**RESOLUTION NO. R26-67**

A RESOLUTION OF THE MAYOR AND COUNCIL OF THE CITY OF COLUMBUS, NEBRASKA, APPROVING CHANGE ORDER NO. 1 TO THE CONSTRUCTION CONTRACT WITH RUTJENS CONSTRUCTION, INC. IN THE AMOUNT OF \$17,854.85 FOR CHANGE PROPOSAL REQUESTS 1 THROUGH 5 FOR COLUMBUS NORTH WELL NO. 20 PROJECT.

## CHANGE ORDER NO. ONE

Owner: City of Columbus, Nebraska  
Engineer: HDR  
Contractor: Rutjens Construction, Inc.  
Project: Columbus Well No. 20

FILENAME | 10425904-05-E-M  
SCALE | 3/8" = 1'-0"  
SHEET | 20E101

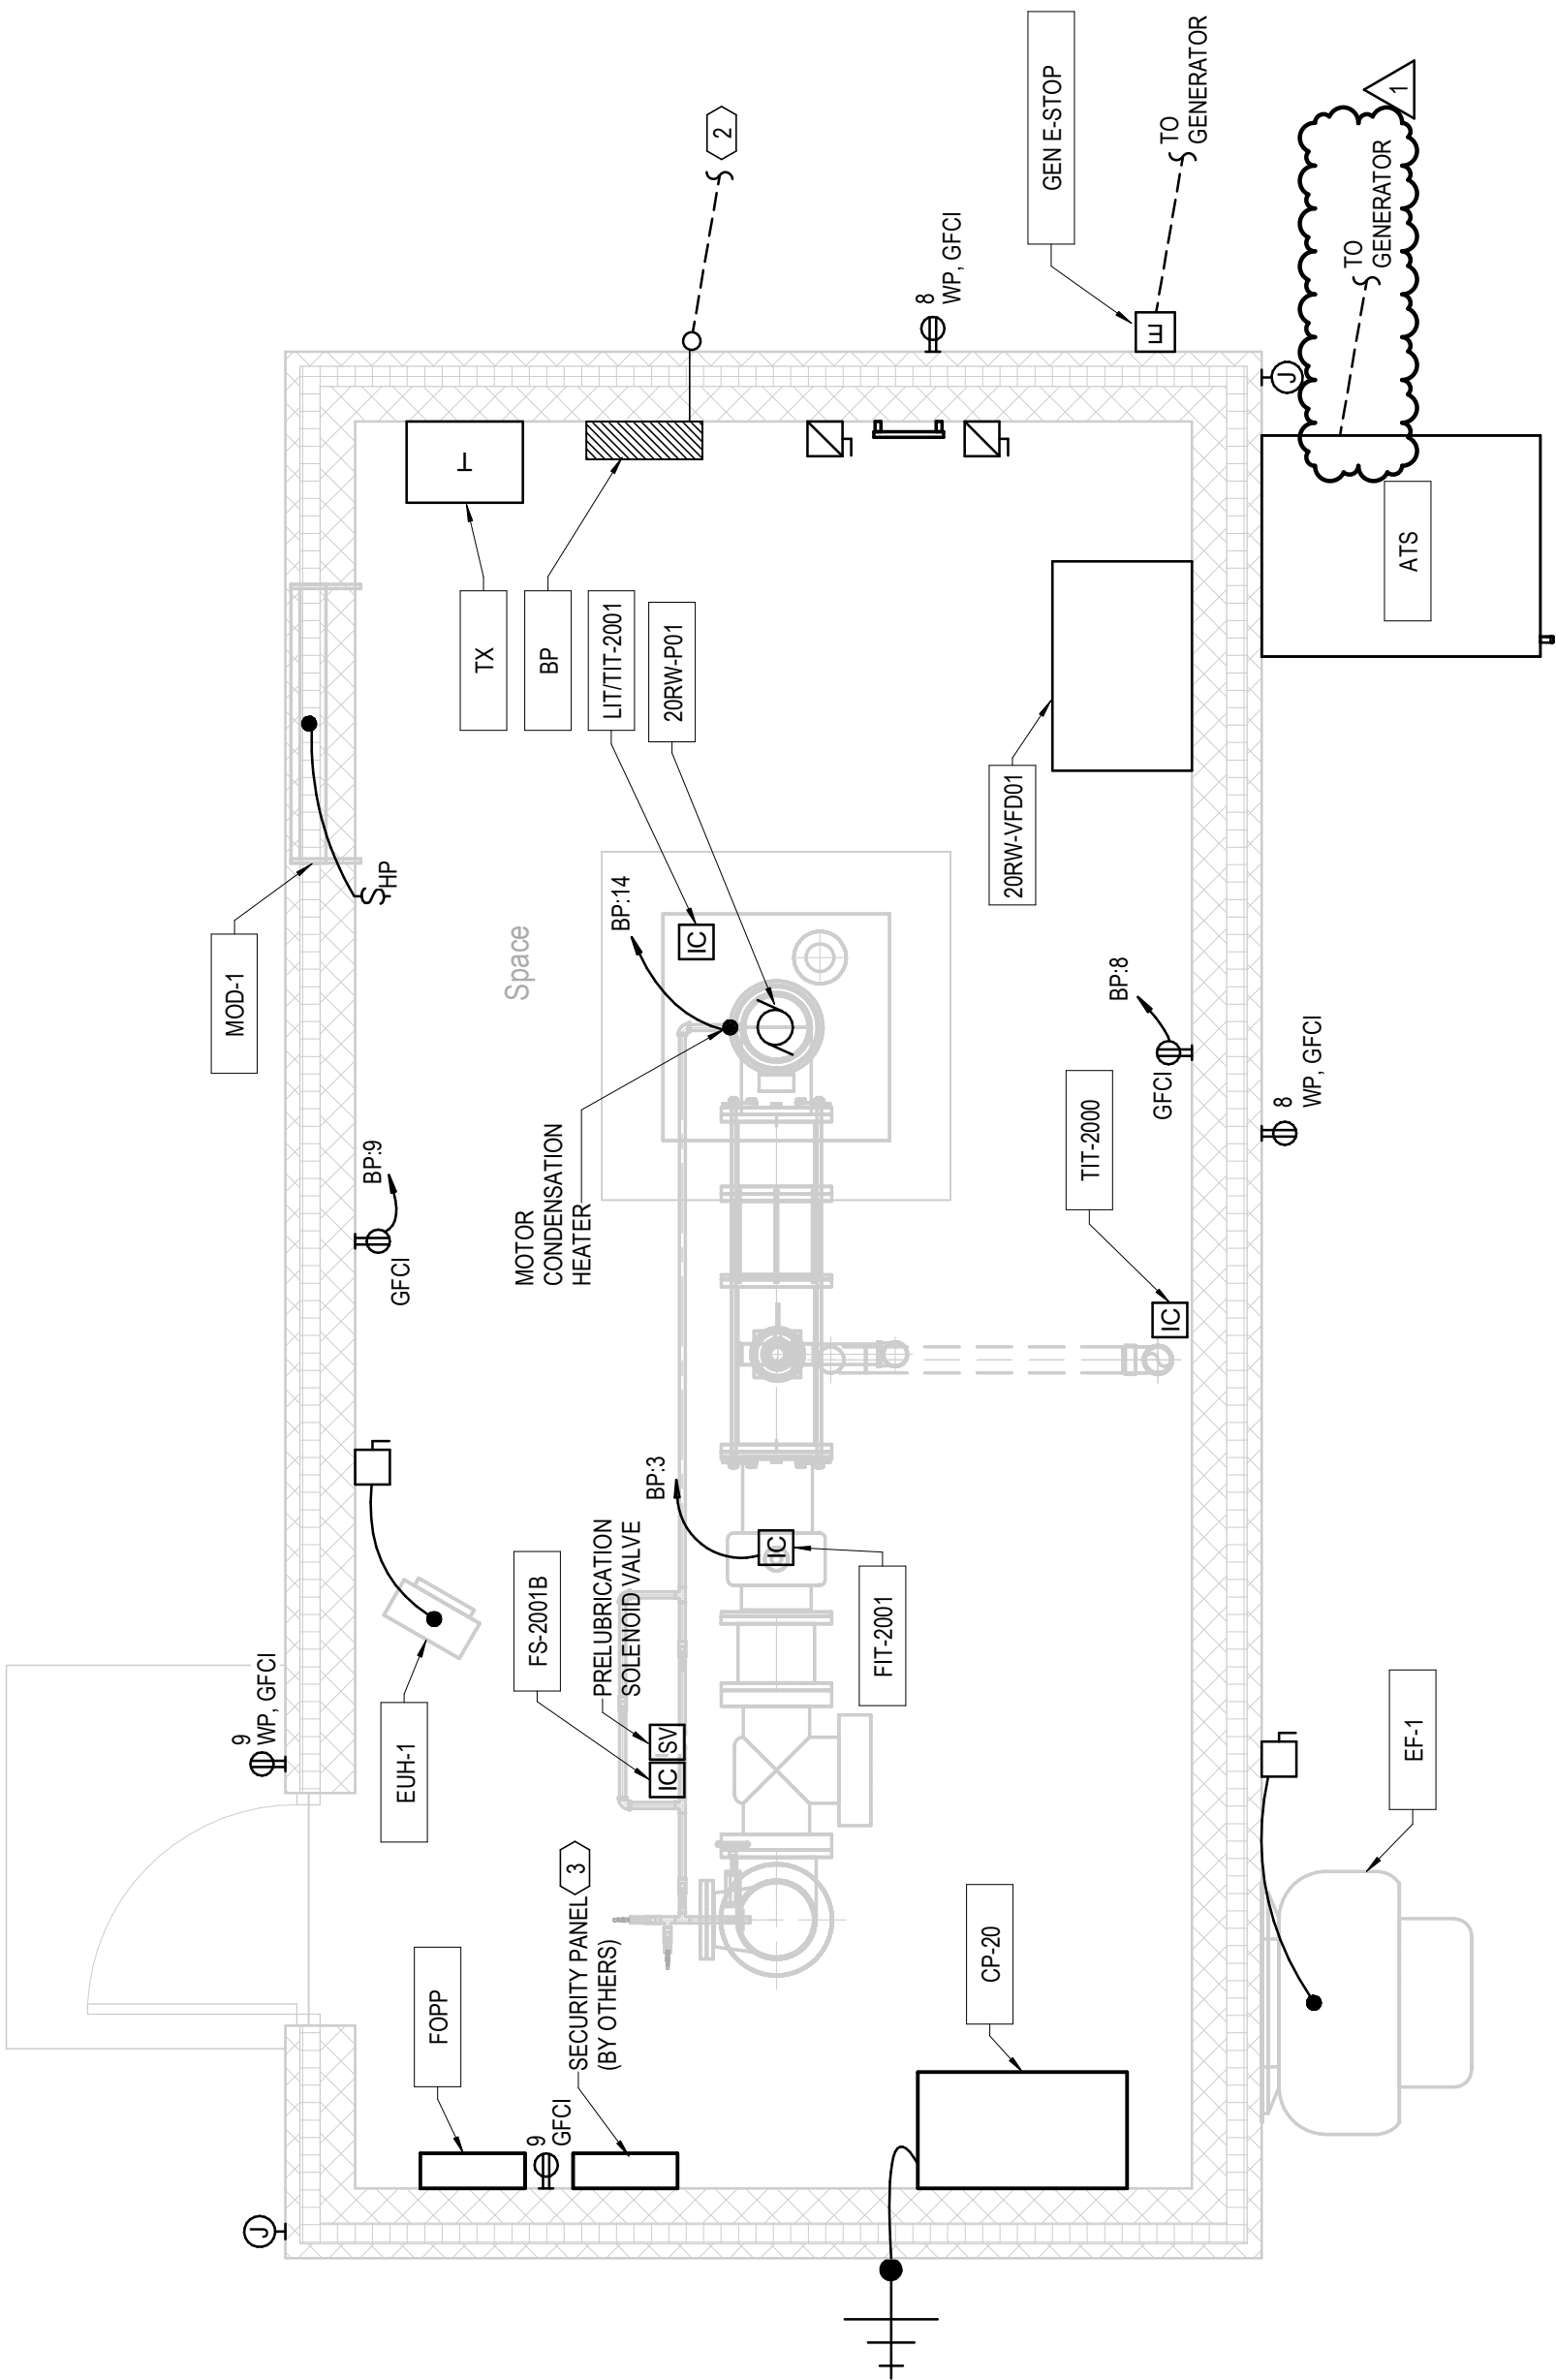
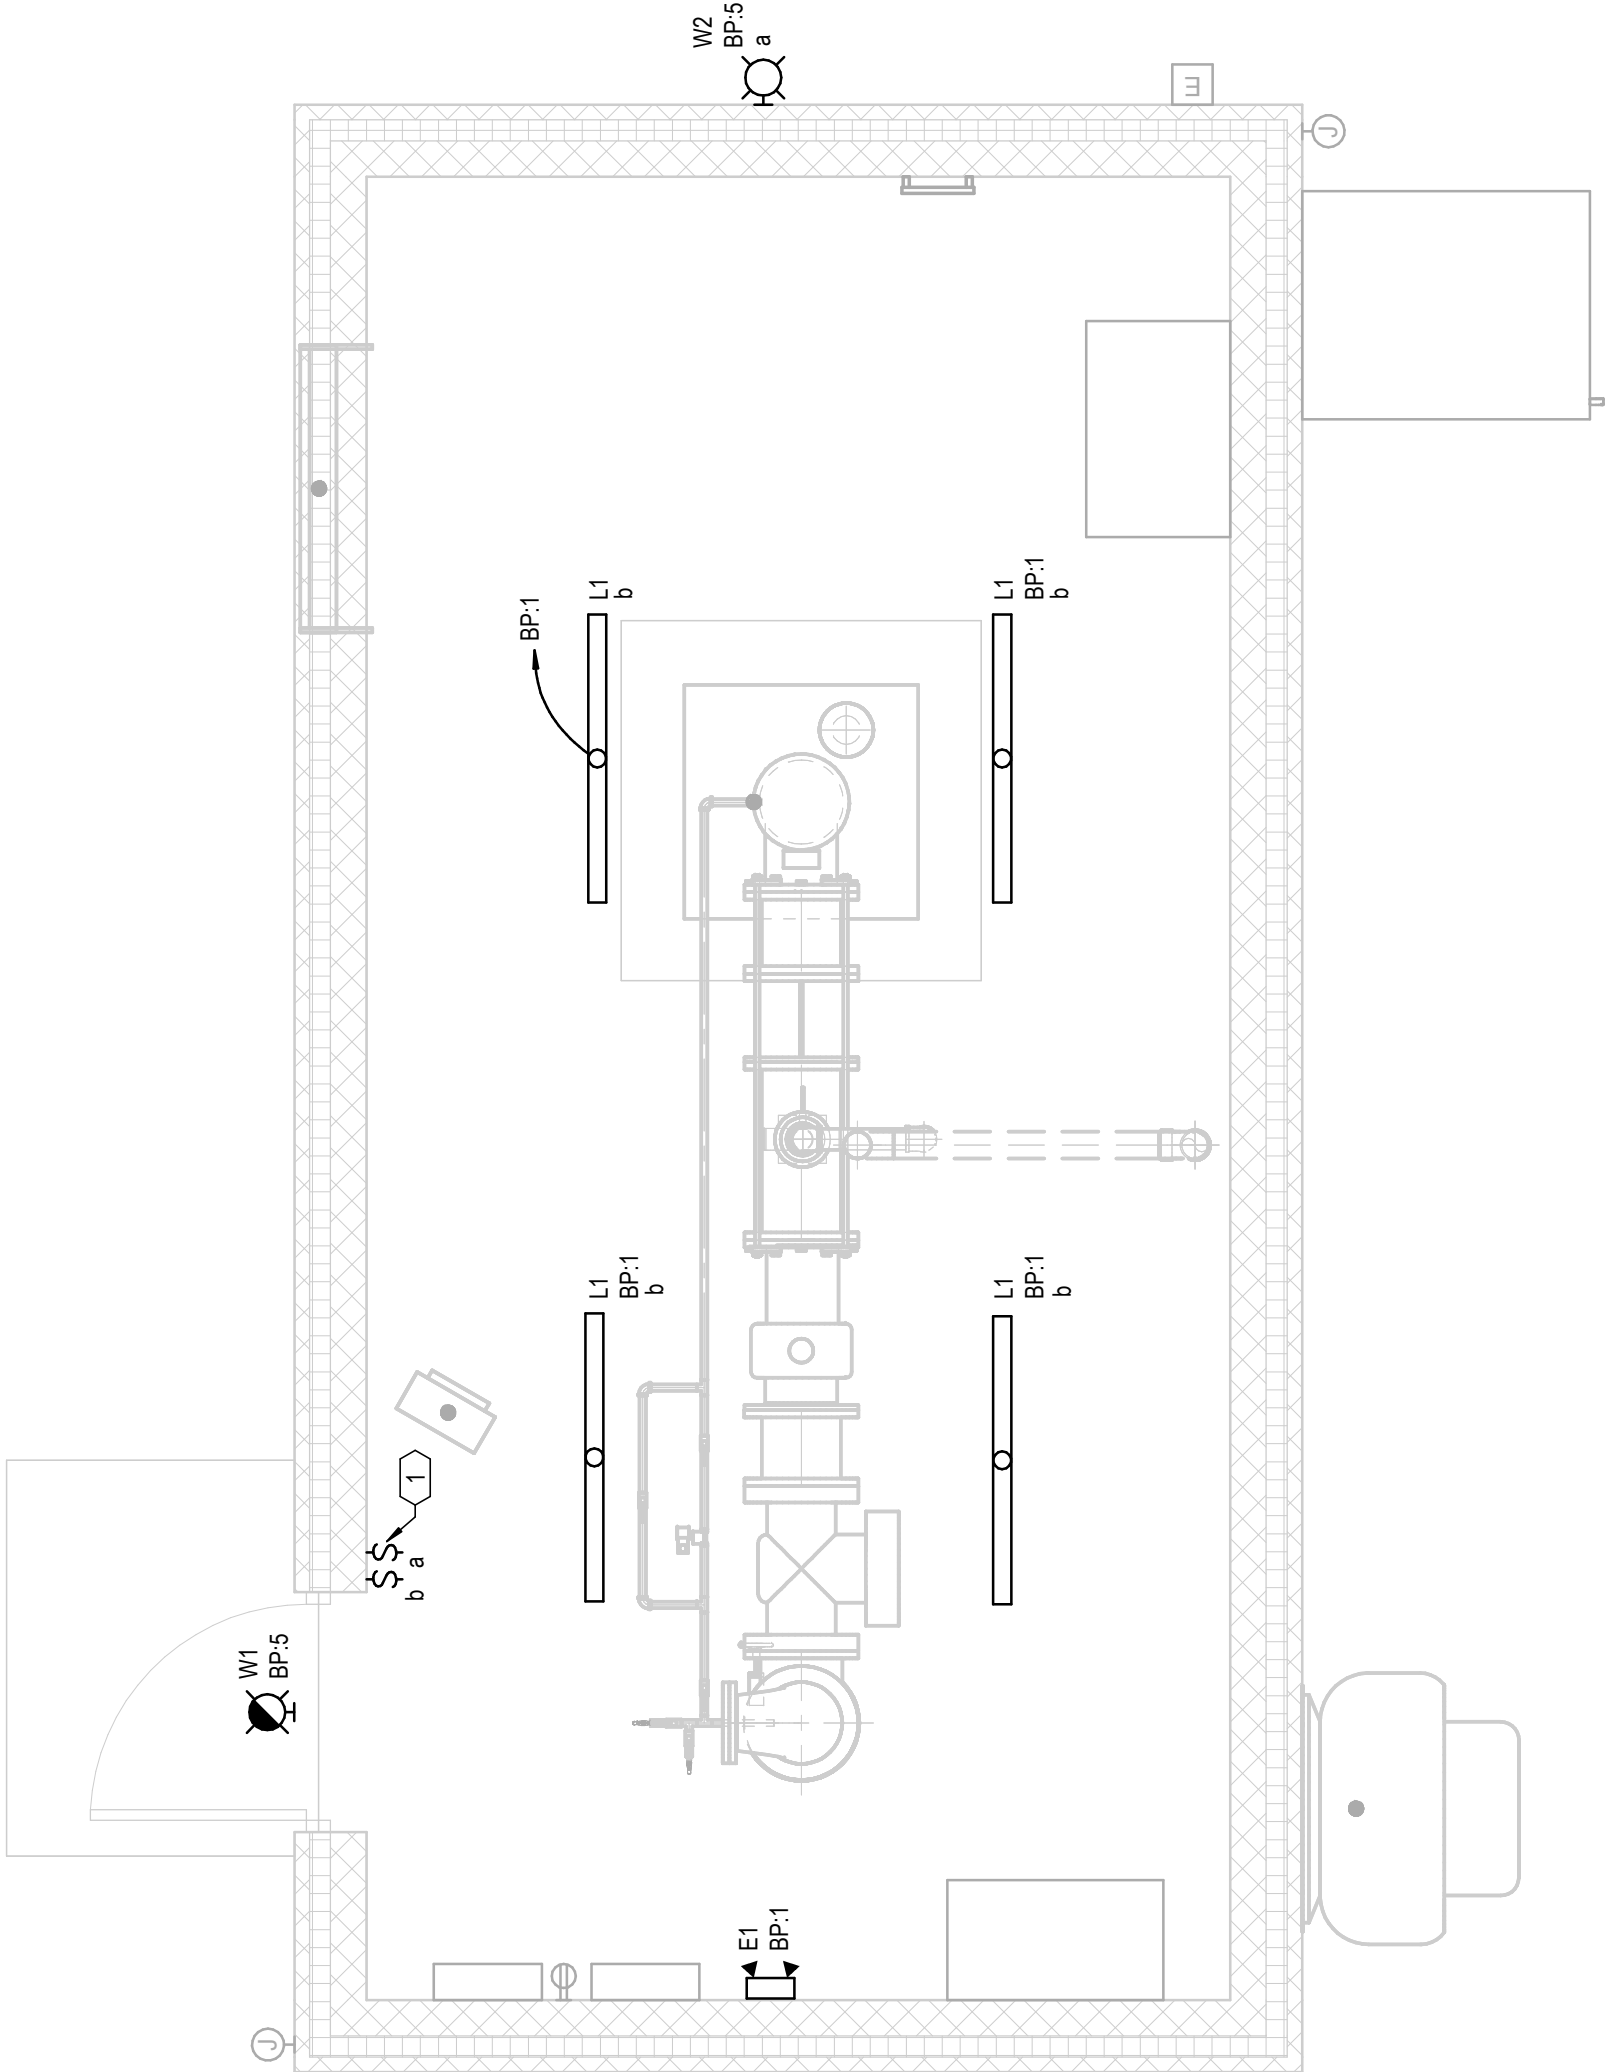
1. Submittal 26 32 13.13 for the Diesel-Engine-Driven Generator detailed 6#14 conductors required between the ATS and the generator. These conductors are to be added as part of this proposal request.

**SHEET**  
**01E101**

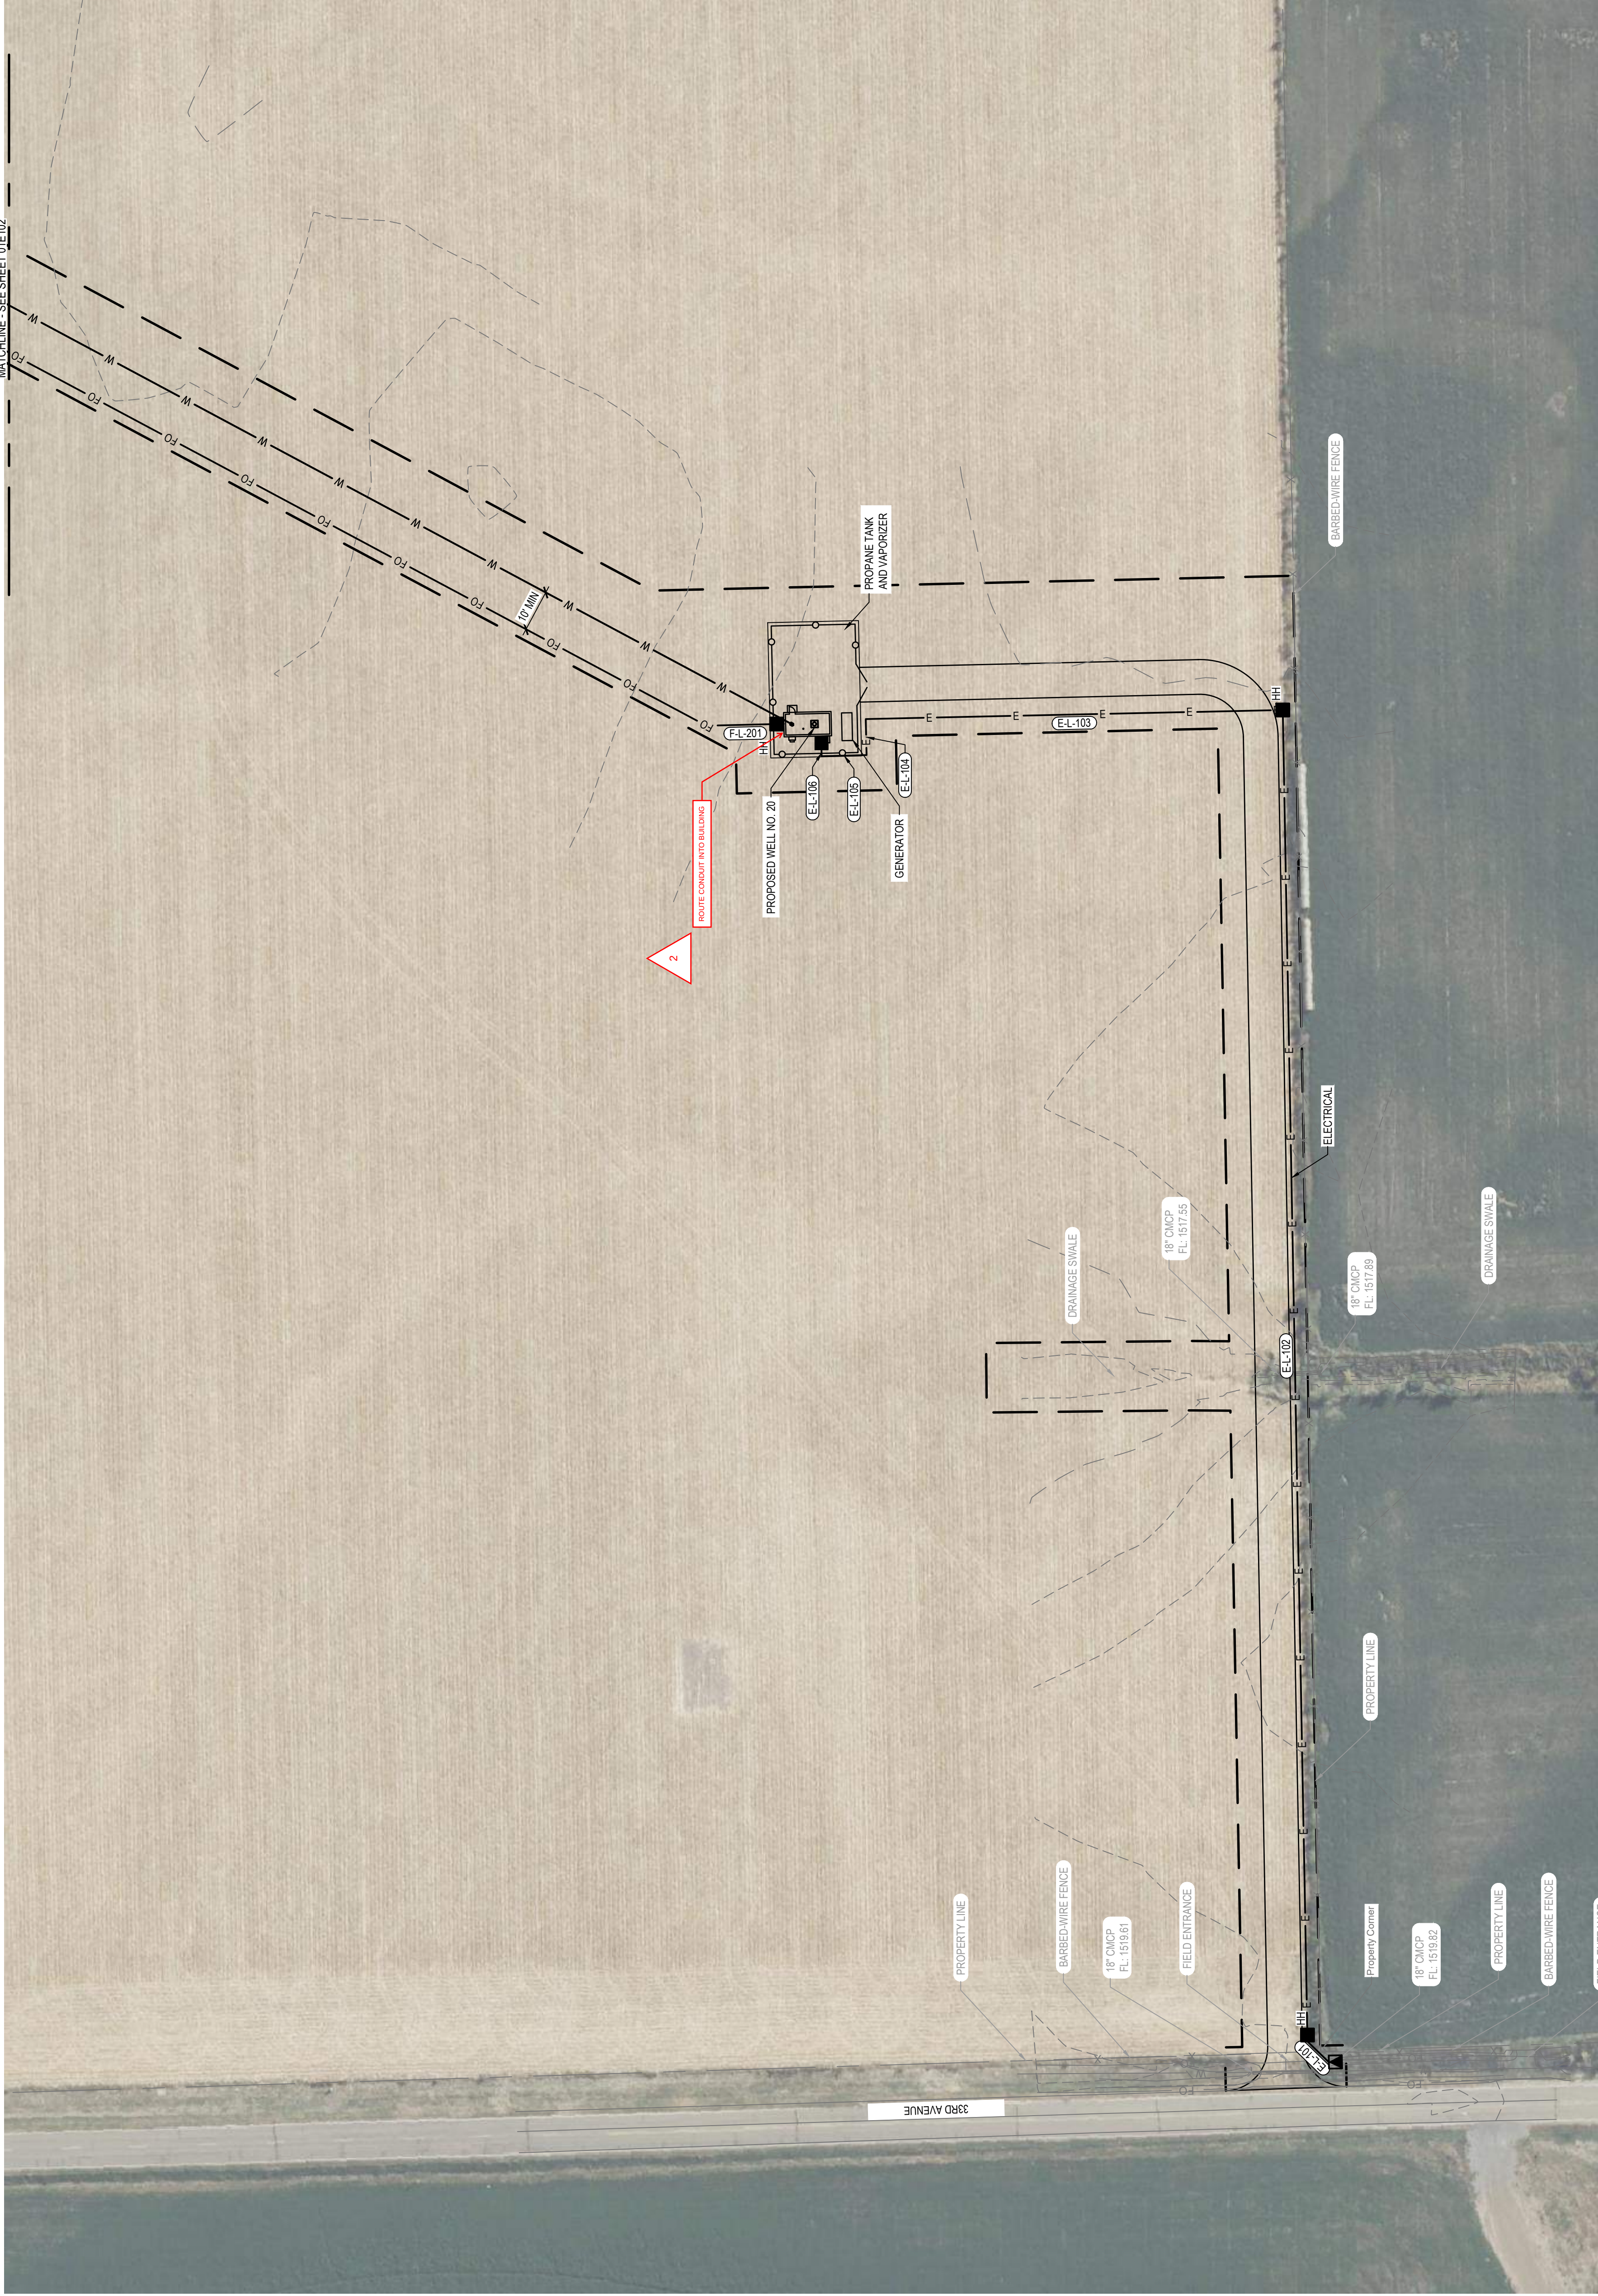
1. Route Conduit into the six well house buildings and into the Water Treatment Plant (WTP) building and into the Booster Station building.
2. Add a hand hole on the south side of the WTP building and add hand hole on the east side of the Booster Station building.

1. Plan sheet(s): 01E101 through 01E105 revised to show conduit into structures and two additional hand holes.
